# NRC Regionwide River Flood Model - Peer Review

Review of Calibration Model and Report

Prepared for Water Technology

Prepared by Beca Limited

Figure 1 - Kawakawa catchment rainfall hyetograph and flow hydrographs for 19-31 January 2011

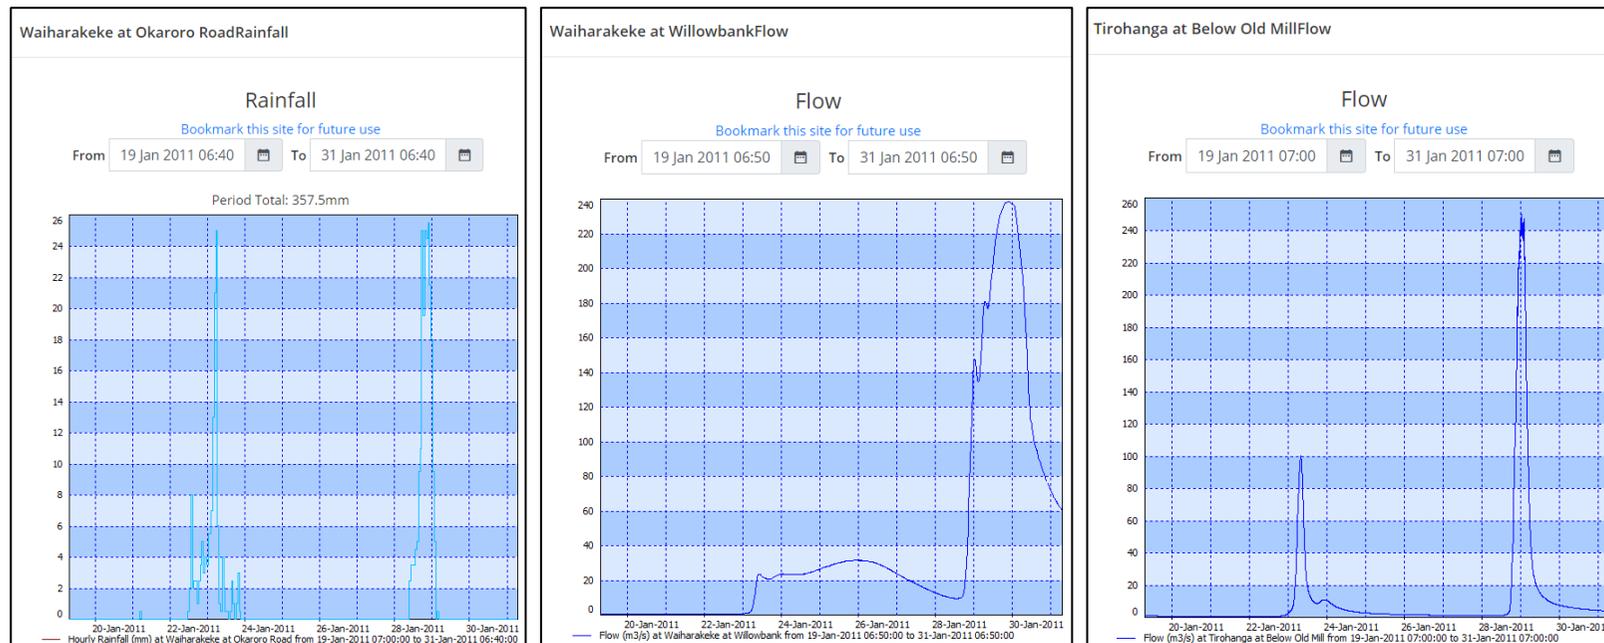
Report item	Ref	Beca Findings & Comments	Water Technology (WT) Response / Action Taken	Initial Audit Rating	Final Audit Rating	Open/Closed												
Section 1 Page 9	R1	<p><u>14 January 2021: 5<sup>th</sup> paragraph:</u> This paragraph reports the dates of the storm/flood events used for calibration, including the 28 January 2011 event. That event was preceded by heavy rainfall across the regions 6-7 days earlier (see Figure 1 and Figure 2). Rainfall totals for gauges in three of the calibration gauges were:</p>

<p>Would soils have still been saturated and catchment surface storage not fully drained prior to the onset of rainfall on the 28 Jan? If so, then the recorded flows and flood volumes could be expected to be significantly higher than modelled flows that do not account for these antecedent conditions.</p> <p>This would affect the perceived performance of the calibration models against NRC's calibration criteria.</p> <p><u>26 January 2021:</u> While flows may have dropped back to normal low flows prior to the 28 January 2011 event, I was concerned that the catchment would still be saturated, resulting in greater than expected runoff from the 28 January event. I've had a look at soil moisture data for Kerikeri (downloaded from Cliflo), which indicates that soil moisture had almost dropped back to normal to levels.</p> <p>So, how can the difference in hydrographs (catchment response) shown in Figures 1 and 2 be explained.</p> <p><b>NRC need to agree WaterTech's response</b></p>	Catchment (rain gauge)	21/23 Jan	28/29 Jan	Awanui (Te Rore)	105 mm	116 mm	Kawakawa (Okaroro Rd)	130 mm	217 mm	Whangarei Glenbervie (Forest HQ)	175 mm	257 mm	<p><u>22 January 2021:</u> The impact of the rainfall event in the preceding week is likely to have impacted on antecedent conditions. When undertaking the calibration for this event, suitable loss values were used to account for this and provided closely match modelled water levels at the streamflow gauges. This helps identify a range of catchment antecedent conditions that can be used for design modelling.</p> <p>A sensitivity test which included preburst rainfall (10mm depth rainfall 5hr prior the event) has shown that minor impacts were found on the modelling results. In addition, according the flow records in the calibration gauges, the flows from the first event had been attenuated to a low flow prior the calibration events.</p> <p><u>NRC comment 5 February 2021:</u></p> <p>As mentioned under point 1) above the model calibration has focused on replicating the recorded flood behaviour levels, i.e. FIT FOR PURPOSE in light of the purpose and 'audience' of the flood maps.</p>	2	1	Close as agreed by NRC
Catchment (rain gauge)	21/23 Jan	28/29 Jan																
Awanui (Te Rore)	105 mm	116 mm																
Kawakawa (Okaroro Rd)	130 mm	217 mm																
Whangarei Glenbervie (Forest HQ)	175 mm	257 mm

Plots provided by WaterTech (22 January 2021) in response to R17

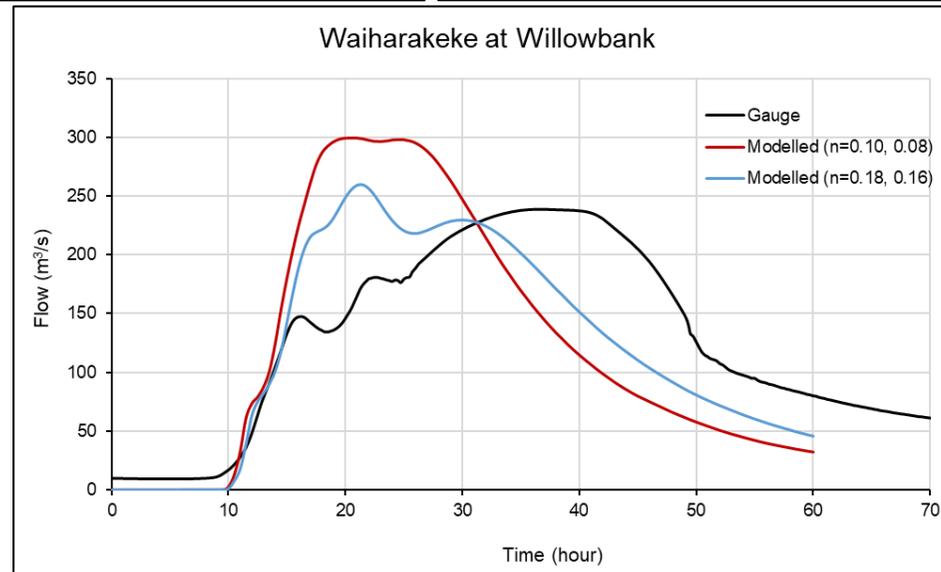
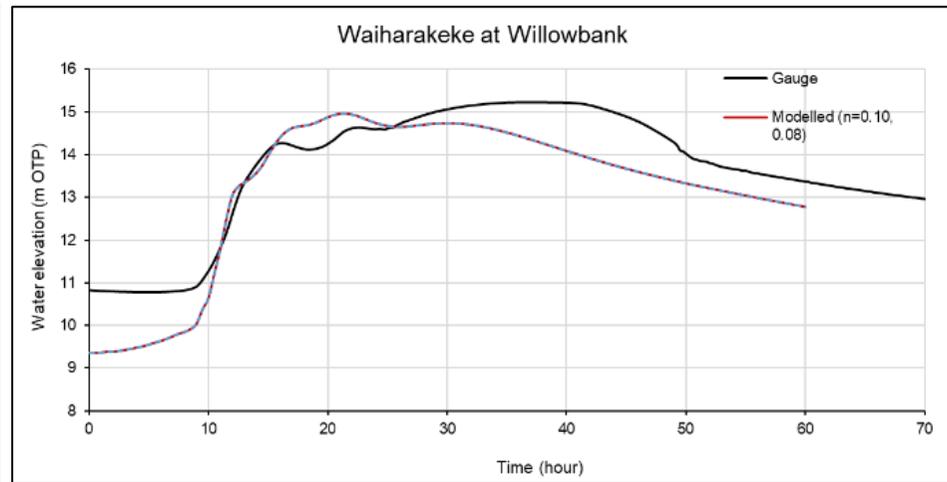
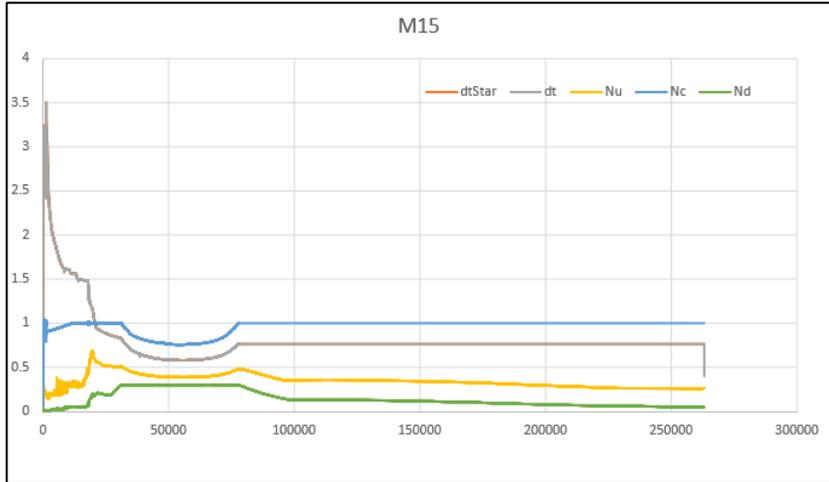
Report item	Ref	Beca Findings & Comments	Water Technology (WT) Response / Action Taken	Initial Audit Rating	Final Audit Rating	Open/Closed
Table 5-2 Page 51	R17	<p><u>14 January 2021</u>: The <b>catchment roughness and rainfall loss</b> parameters shown in the table are as modelled.</p> <p>The Mannings roughness values of 0.16 and 0.18 for the Upper Kawakawa are high for floodplains, but could be appropriate for overland/sheet flow.</p> <p>Are there known difficulties in TUFLOW modelling rain-on-grid over steep catchments, and if so, are the high 'n' values adopted to overcome these issues, or are they a true reflection of the hydraulic characteristics?</p> <p><u>26 January 2021</u>: Explanation of roughness accepted, as is the acknowledgement of issues around steep catchments, and how HPC deals with it.</p>	<p><u>22 January 2021</u>: The roughness values were calibrated through matching the modelled water levels with the records at Willowbank gauge.</p> <p>The material roughness and loss/infiltration layers have been developed at a catchment wide scale. The level of detail provided in the model has been based on catchment wide modelling and where possible, catchment conditions have been lumped together with the aim of producing fit for purpose modelling results.</p> <p>The roughness values adopted for the upper Kawakawa are on the higher side and are high to take into account the relatively dense forested area and higher vegetation across the floodplain. The figures below show the gauged flow/water level hydrographs using lower roughness values (<math>n = 0.10</math> and <math>0.08</math>) compared to current calibrated values.</p> <p>Steep catchments have previously presented instability issues when using rain-on-grid within TUFLOW Classic. TUFLOW HPC is inherently more stable due to being an explicit finite solver. The three key control numbers which adjust the timestep that the explicit solution can use are:</p> <ul style="list-style-type: none"> <li>• Courant Number, <math>Nu</math></li> <li>• Wave Celerity Number, <math>Nc</math></li> <li>• Diffusion Number, <math>Nd</math></li> </ul> <p>A review of the model health shows the model timestep remains relatively stable through the model run. Generally, the <math>Nc</math> appears to be the controlling factor within the model.</p>	2	1	Closed
